Access Compliance Report

Public Rights-of-Way

(Curb Ramps)

Intersection ID: 5713	Main Street: RIDGE_ACRES_RD	Cross Street: TRAILING_ROCK_DR	Location:	N
ADA ID: A708DCD188F2	Ramp Type: Perp	Initial Pass/Fail: Fail	Overall Compliance: No	Severity Score: 10
Codes/Mitigation Info/Possible Solution		Field Measurements/Component Compliance

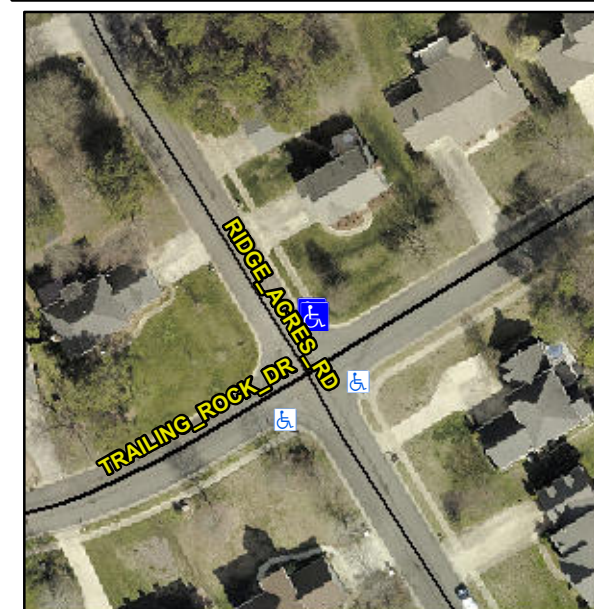
Not Found, R304.5.1, R304.5.3

Compliance	Description	Data	Compliance	Description	Data
N/A	Ramp Length (in)	36.0	Yes	Ramp Slope (%)	6.7
No	Ramp Width (in)	47.5	No	Ramp XSlope (%)	2.1
N/A	Flare Type LT	N/A	N/A	Flare Type RT	N/A
N/A	Flare Slope LT (%)	N/A	N/A	Flare Slope RT (%)	N/A
N/A	Flare Traversable LT?	N/A	N/A	Flare Traversable RT?	N/A
N/A	Landing Length (in)	N/A	N/A	DWS Provided?	N/A
N/A	Landing Width (in)	N/A	N/A	DWS Contrast?	N/A
N/A	Landing Slope (%)	N/A	N/A	DWS Length (in)	N/A
N/A	Landing X Slope (%)	N/A	N/A	DWS Full Width?	N/A
N/A	Landing Curb? (Y/N)	N/A	N/A	DWS Offset (in)	N/A
N/A	Shared Landing?	N/A			
N/A	Gutter Ponding?	N/A	N/A	Gutter Slope (%)	N/A
N/A	Gutter Lip Ht (in)	N/A	N/A	Gutter X Slope (%)	N/A
N/A	Painted X Walk1?	No	N/A	Painted X Walk2?	N/A
	X Walk 1 Direction	To S		X Walk 2 Direction	N/A
N/A	X Walk 1 Width (in)	N/A	N/A	X Walk 2 Width (in)	N/A
	X Walk 1 Slope (%)	1.2		X Walk 2 Slope (%)	N/A
	X Walk 1 X Slope (%)	3.7		X Walk 2 X Slope (%)	N/A

Remove & Replace Entire Ramp.
